## **SUBDIVISION REVIEW SHEET**

**CASE NO.:** C8J-2019-0141.3A

**SUBDIVISION NAME:** Skyline 2-D Phase 3 Final Plat

CITY OF AUSTIN –DEVELOPMENT SERVICES DEPARTMENT  
SUBDIVISION APPLICATION – MASTER COMMENT REPORT

## SHEET NO. 2 OF 4

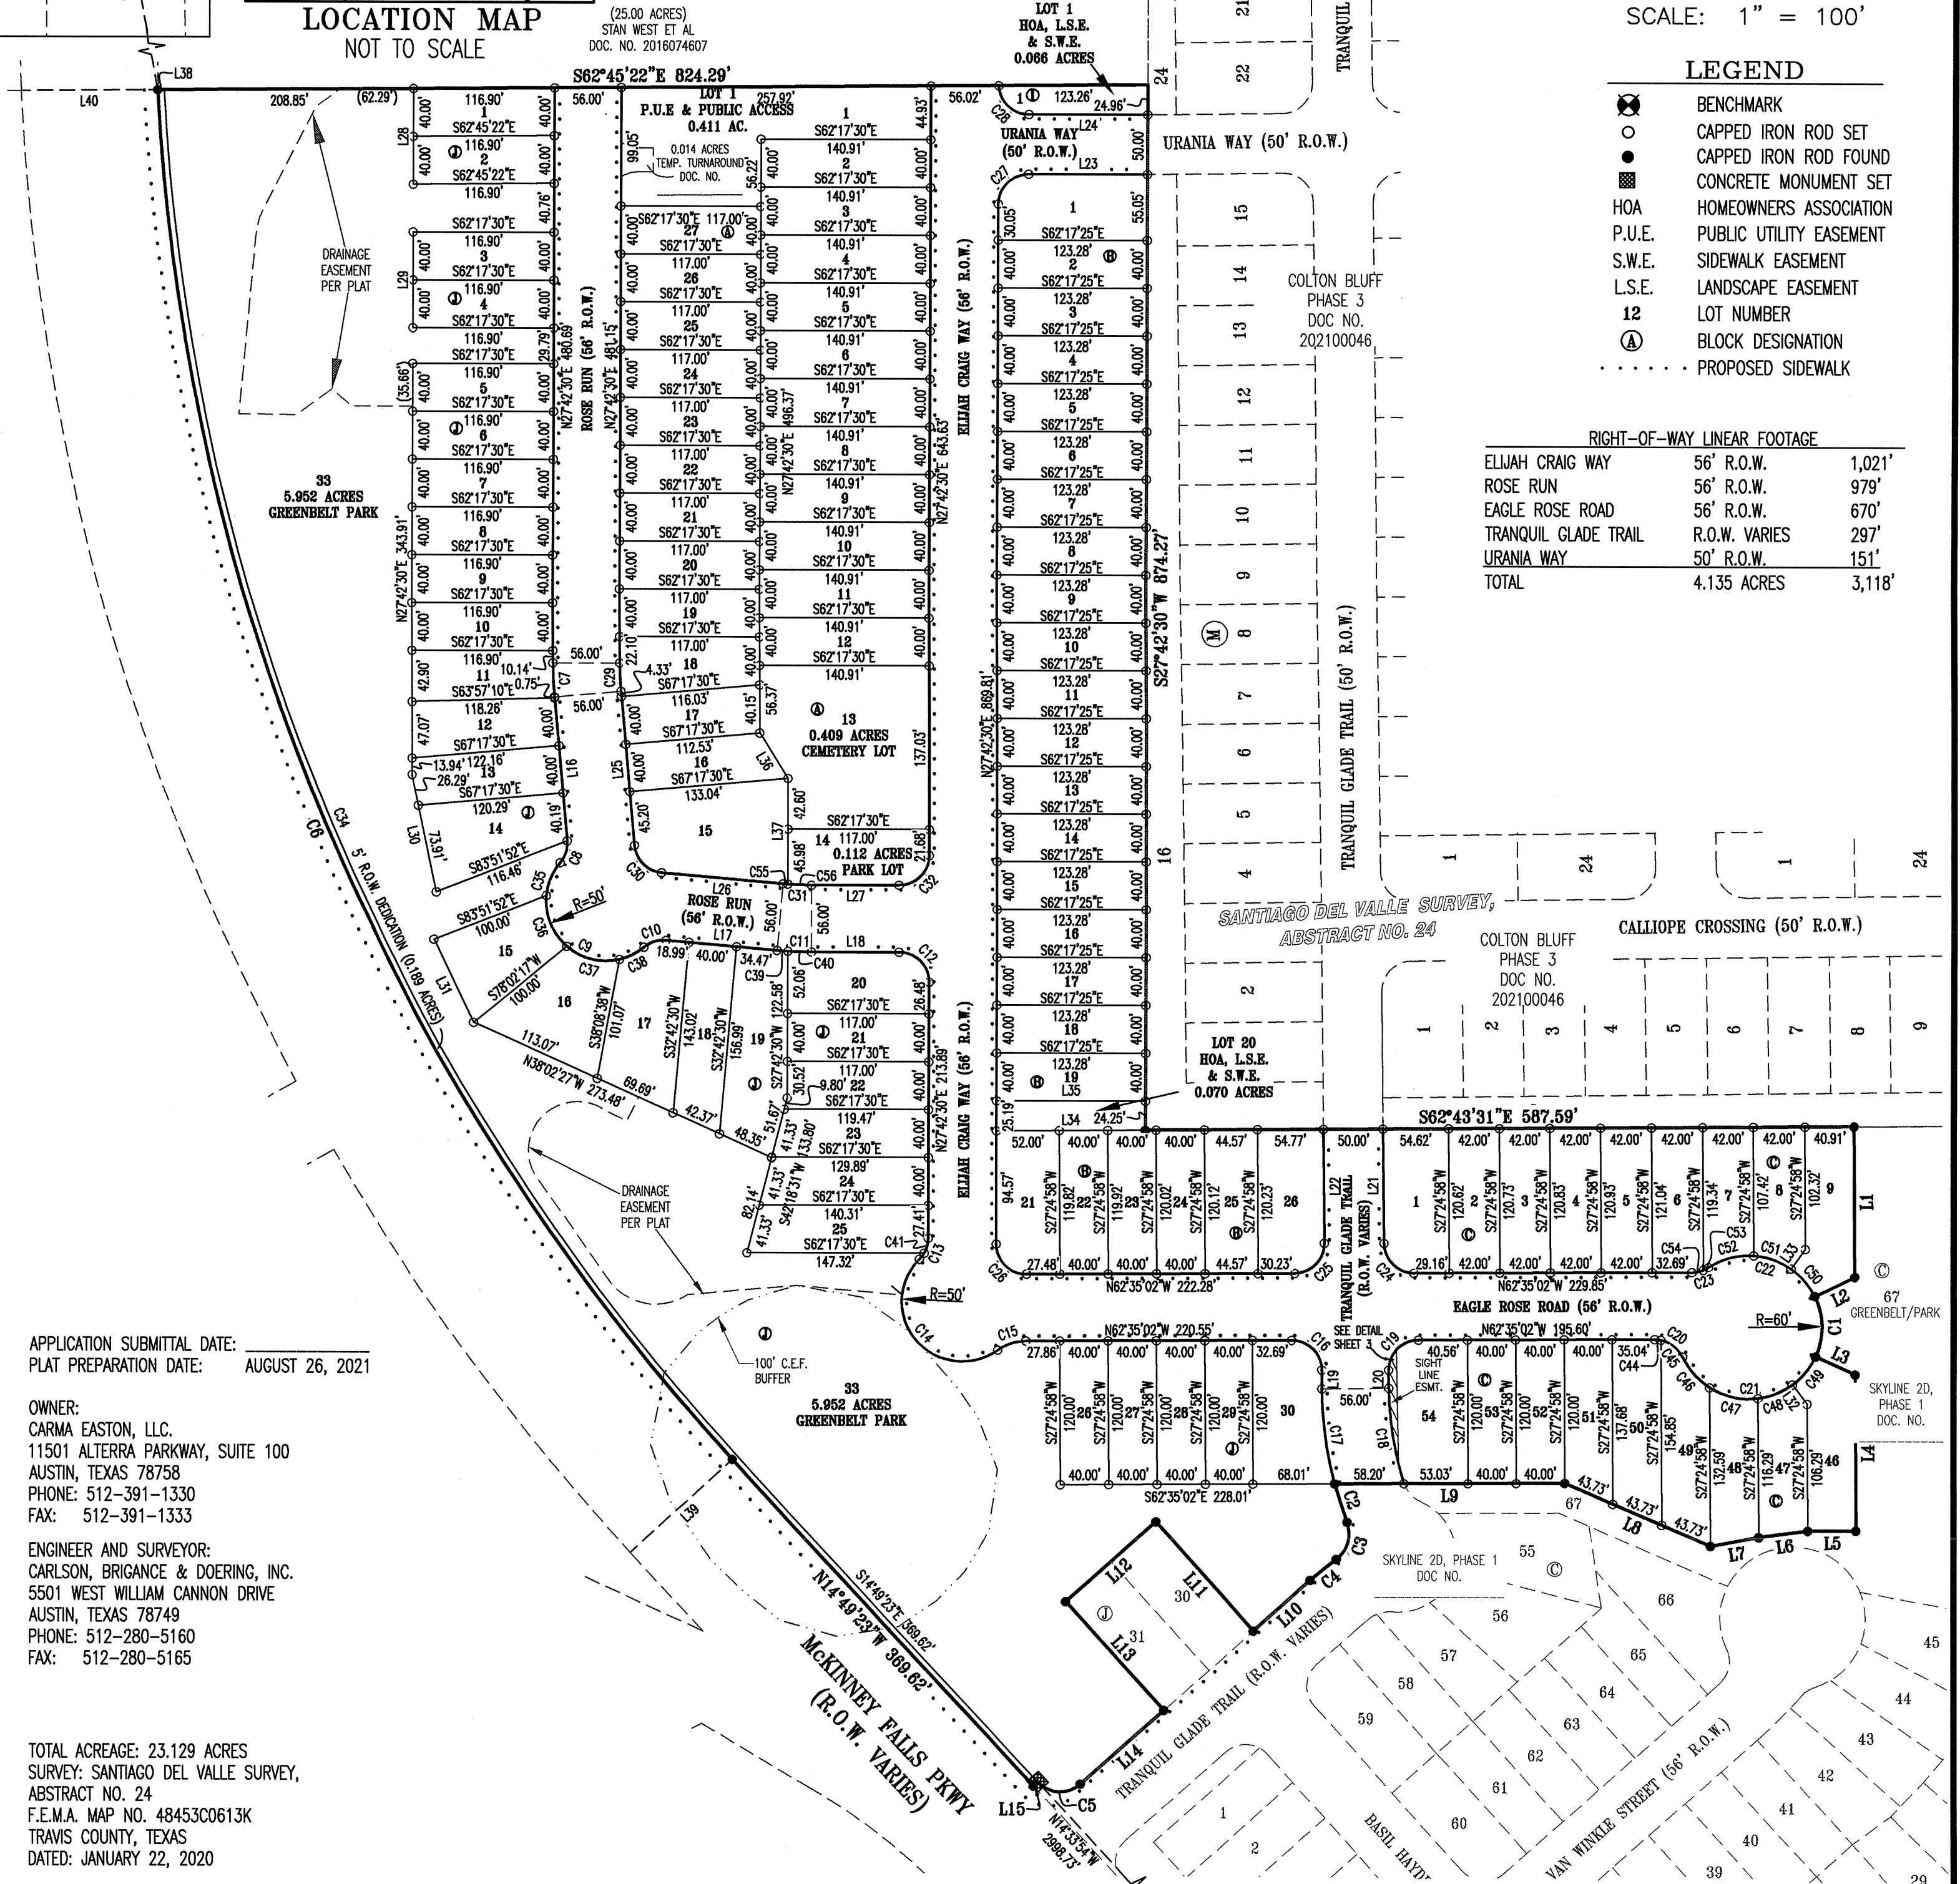
AD2: ROSE RUN - this may be a duplicate – please contact this reviewer to discuss.

**WB1. Update0.** Please clearly show the boundaries of the one wetland CEF on the plat to be preserved and clearly label the feature “Wetland CEF” on the plat.

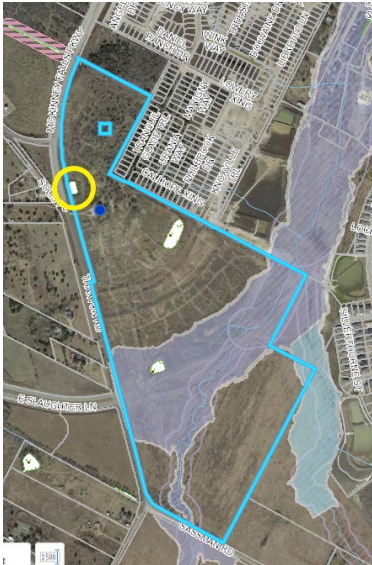
FYI A previously identified CEF (BRG ID 207041) was identified and field verified by WPD staff within 150-feet of the plat (circled in yellow in the screenshot below). Please see the screenshot below of the approximate location and boundaries of the wetland CEF circled in yellow which is available on Property Profile Tool. In addition, the Shapefiles for the wetland CEF is available on Property Profile to be downloaded.

**WB2. Update0.** Please remove the wetland CEF setback from the plat. FYI all CEF setbacks will be addressed during the site plan/subdivision phase.
